56. Introduction to Ethernet for subscriber access networks

56.1 Overview

Change the second paragraph in 56.1 (as modified by IEEE Std 802.3ca-2020) as follows:

Figure 56-7—Architectural positioning of EFM: P2MP Super-PON Architecture

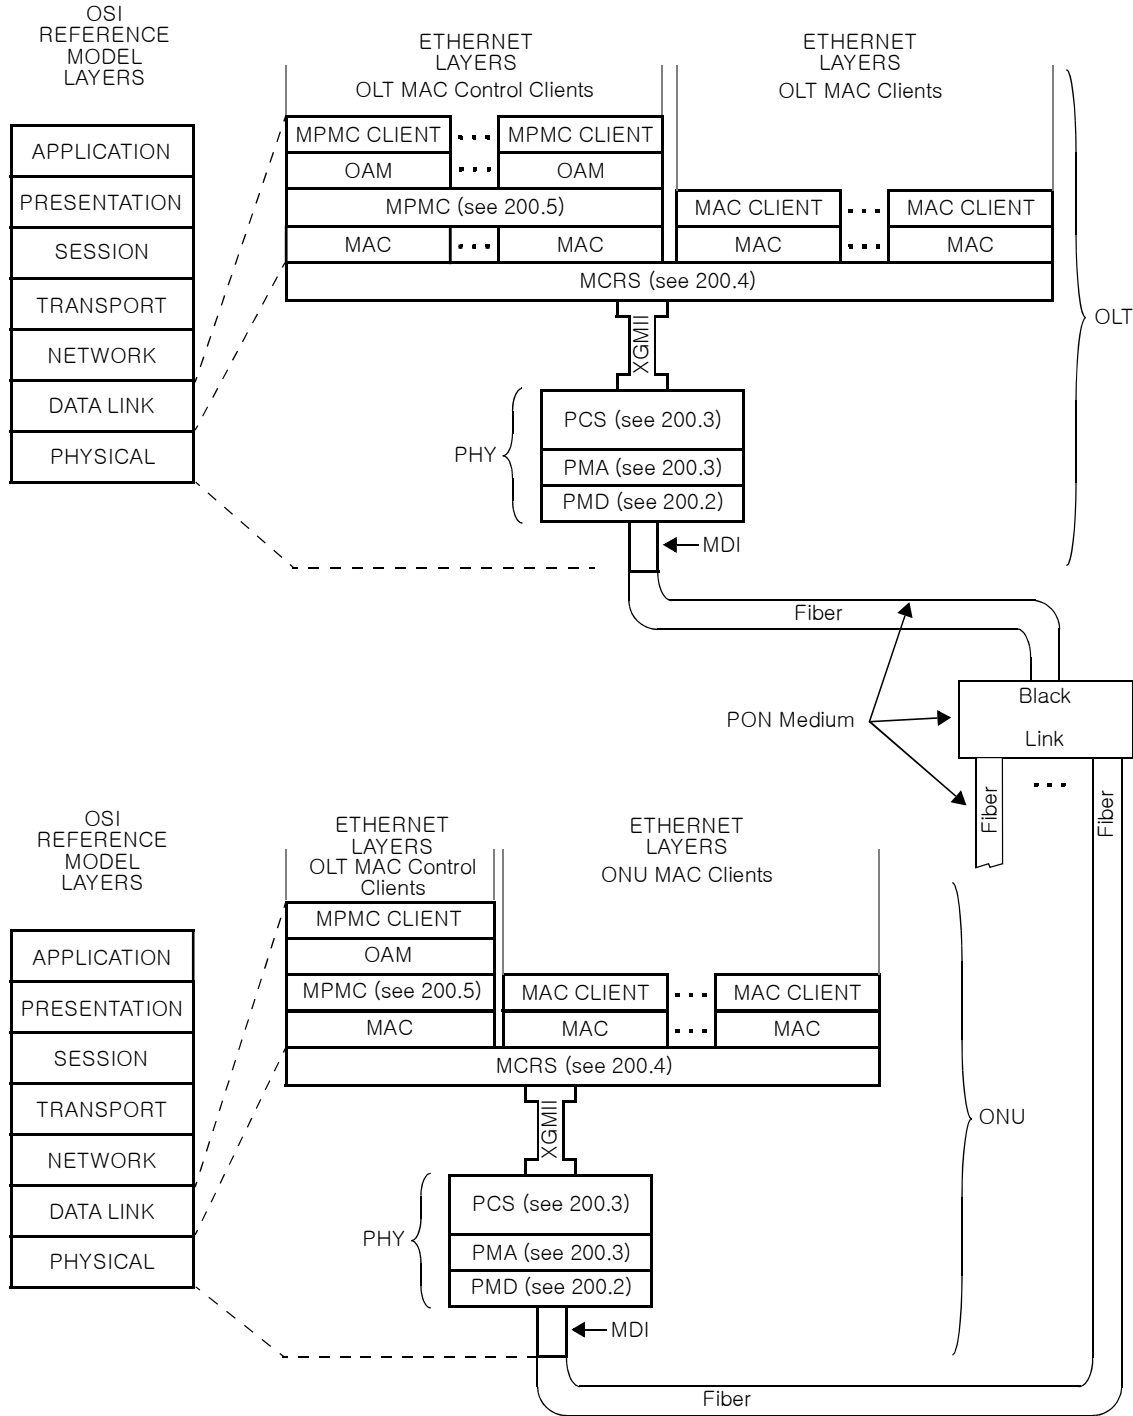
Insert new Figure 56–7 (as shown on the next page) after Figure 56–6. Change the last paragraph in 56.1 as follows:
